## **Letters Received as of February 21, 2025 Regarding Proposed Transmission Upgrades in Advance of the PJM Board of Managers February, 2025 Meeting**

**Subject:** Opposition to Project 262 2024 Window 1 – (708) 765kV 261-mile transmission line

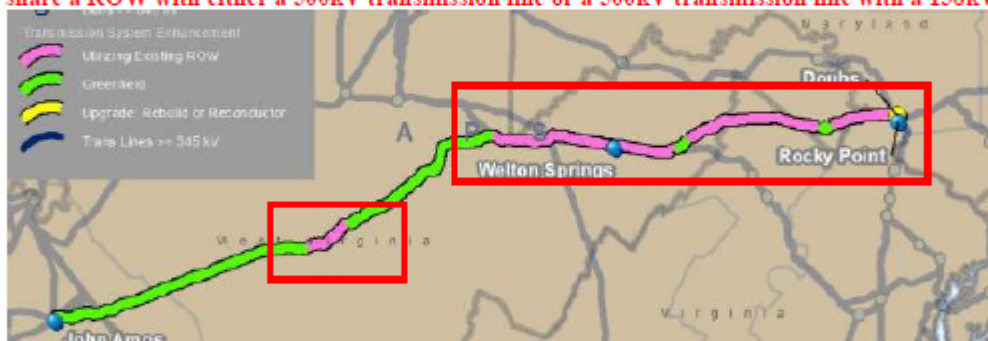
"FirstEnergy, including its participation in the joint venture, has significant experience with the proposed equipment and the capabilities to construct Proposal 708 as submitted. *The proposing entity experience and capability risk is considered low.*"

**The proposing entity experience and capability risk assessment as stated is totally and completely false. These companies have ZERO experience building a 765kV transmission line that makes for a HIGH risk.**

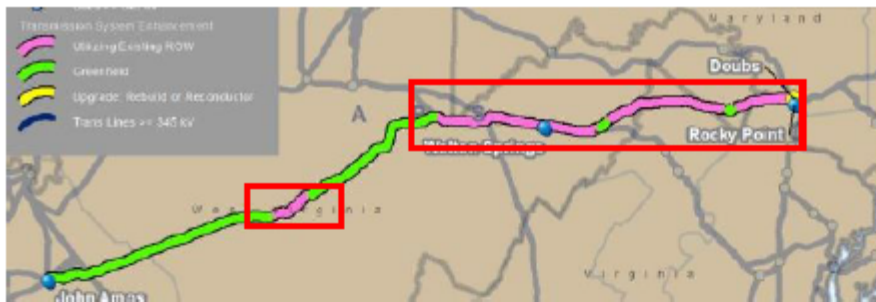
The redacted proposal for Proposal 708 of Project 262 explicitly states it requires a new 200' easement for its entire 261 mile length. Yet, the Constructability Analysis fails to mention a new 200' easement is required for the entire 261 mile length of the transmission line.

The PJM TEAC charts and Constructability Analysis map should show a "green" line indicating Greenfield, for the entire length of the transmission line. **The "pink" segment implying utilization of the existing ROW is a gross misrepresentation of the land acquisition and property impact. A 765kV transmission line cannot share a ROW with either a 500kV transmission line or a 500kV transmission line with a 138kV under built.**

Figure 1: 12/03/2024 PJM TEAC Reliability Update Item 11 pg 78 Proposal

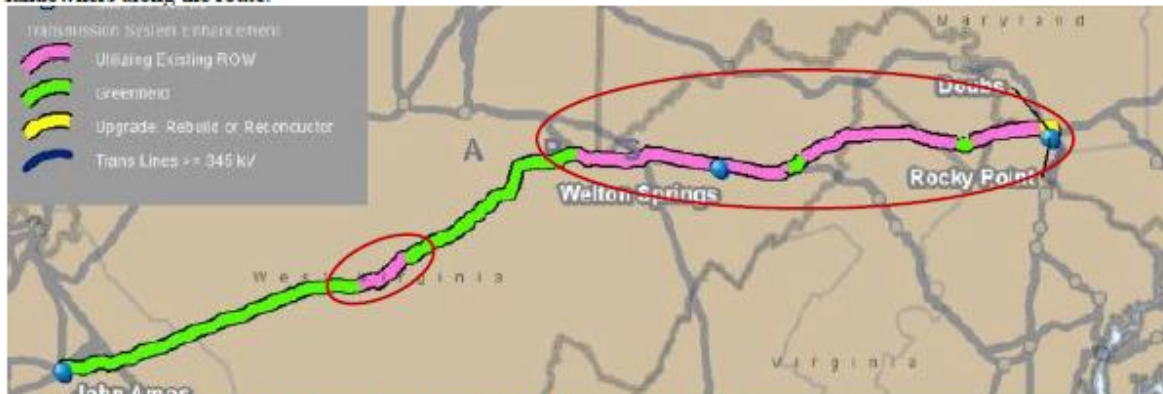
The impacts of this project, especially Proposal #708 , are ridiculously incomplete and totally out of touch with reality. The intent appears to be to deceive the Board by intentionally minimizing the impact this will have on the communities it traverses. The documents contradict themselves . The redacted proposal states that the transmission line will require a new 200' easement for its entire 261-mile length. However, the map implies over half will utilize the existing ROW. The map should show a "greenfield" line for the entire length. Any implication that the existing ROW can be used is not only intentionally misleading but also a flagrant misrepresentation of the land acquisition and property impact to landowners along the route.

There is NO WAY a 765kV transmission line will fit within the existing ROW. The existing ROW contains a 500kV transmission in a 200' easement and a 138kV in a 100' easement. A 765kV line on guyed wire V-Lattice is not going to fit adjacent to the row either. Between the new developments and the roads there is no space left for "parallel" easements without taking out homes. *This is a new 200' greenfield easement through 14 West Virginia counties, 3 Virginia counties and 1 Maryland county, multiple conservation easements and both state and federal parks. Any representation to the contrary is deceptive propaganda.*

Figure 1: 12/03/2024 PJM TEAC Reliability Update Item 11 pg 78 Proposal

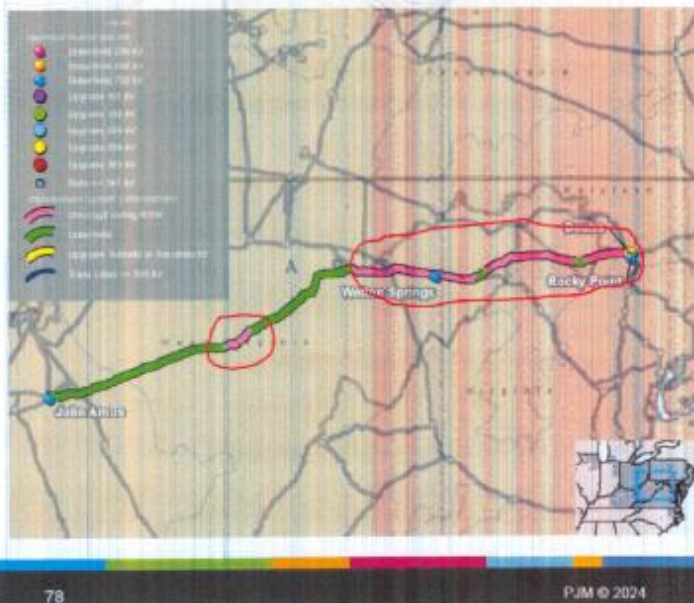
The impacts of this project, especially Proposal 708 , are intentionally and significantly understated. **The redacted proposal states that the transmission line will require a new 200' easement for its entire 261-mile length** . The map should show a "green" line for the entire length to indicate a new greenfield easement. Marking half "pink" as if it will utilize the existing row is a gross misrepresentation of the land acquisition and property impact.

There is NO WAY a 765kV transmission line will fit within the existing ROW. It can't even fit adjacent to the row its will have to "jump" or skirt around existing structures and roads - even then it will destroy many homes. This is a new greenfield easement that will cut a 6,352 acre path of destruction through 14 West Virginia counties, 3 Virginia counties and 1 Maryland county, multiple conservation easements and both state and federal parks.
